STAFF REPORT Date: September 18, 2014

McGowin Park, LLC

Planned Unit Development (East) Planned Unit Development Approval to amend a previously approved PUD to allow multiple buildings on a single building site and allow shared access and parking; and to approve a general sign package for the development.

Planned Unit Development (West) Planned Unit Development Approval to amend a previously approved PUD to allow multiple buildings on a single building site and allow shared access and parking; and to approve a general sign package for the development.

CSP-02

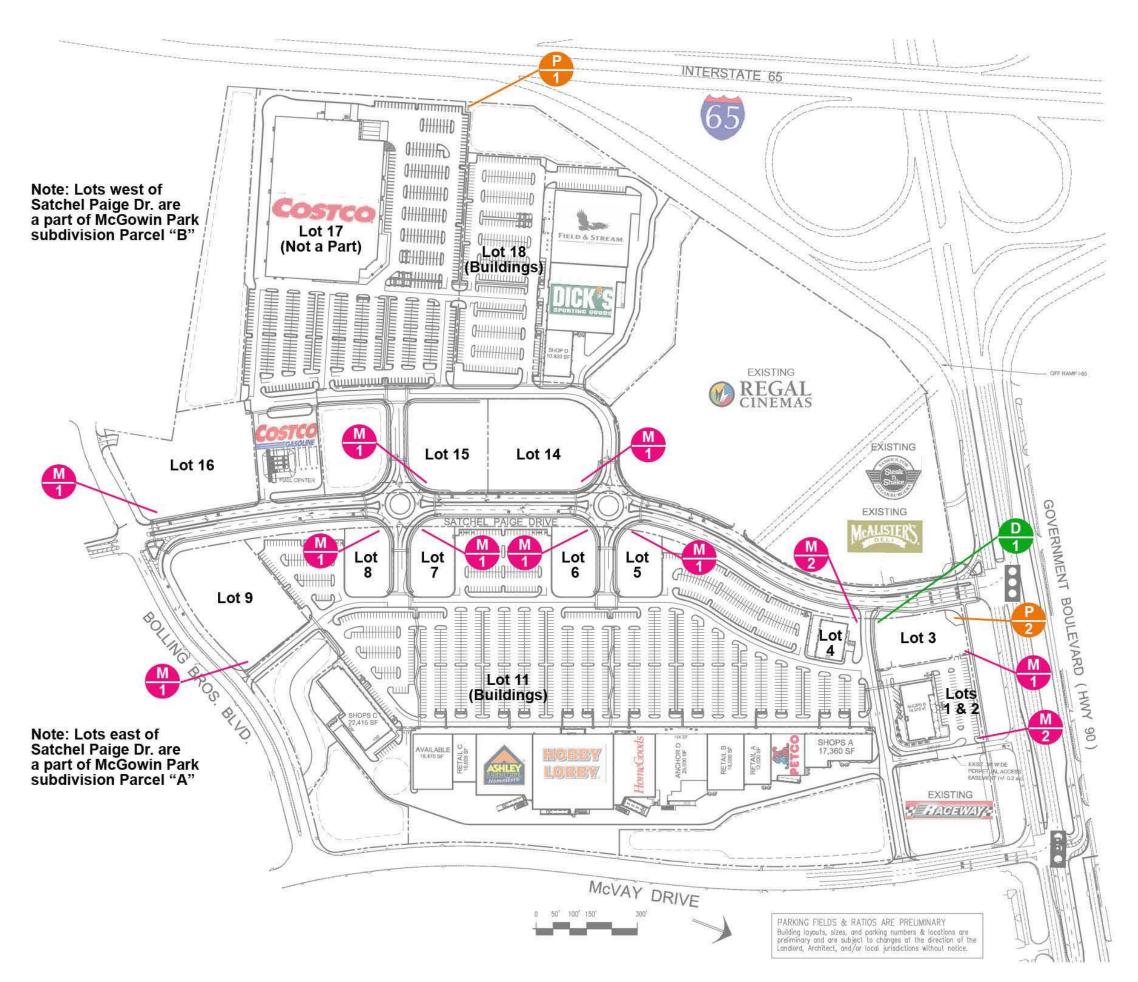
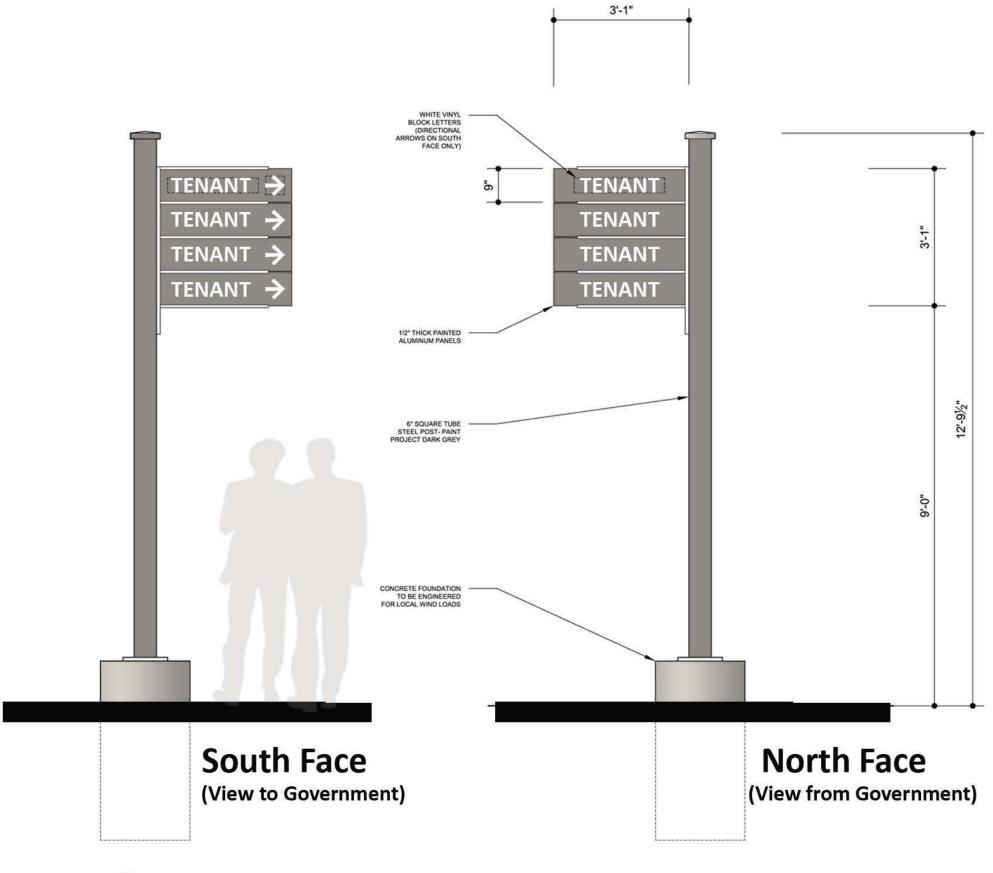
- Freestanding Signs: Two Freestanding Signs are a part of this project; a 50' tall sign on McGowin Park- West Development and a 30' tall sign on McGowin Park- East Development. Both are located on Sheet CSP- 02 and depicted for size and character on Sheet CSP-03.
- Monument Signs: Monument signs shall be allowed in numbers and locations shown on Sheet CSP-02 and as depicted for size and character on Sheet CSP-04. Each Outparcel lot shall be allowed one (1) monument sign.

limited to the sign package as revised for and described in this application and noted on the submitted drawings (a 30' tall free-standing multi-tenant sign on McGowin Park- East Development along I-65, and located on Sheet CSP-02 and depicted for size and character on Sheet CSP-03; Monument signs shall be allowed in numbers and locations shown on Sheet CSP-02 and as depicted for size and character on Sheet CSP-04. Each Outparcel lot shall be allowed one (1) monument sign; For the purpose of wall signs the following are different building types within the overall development: Anchor Tenant Building shall be defined as a tenant space exceeding 12,000 square feet. These tenants shall be allowed additional signage size and types as depicted within the CSP in keeping with the tenant's "national branding". East Development
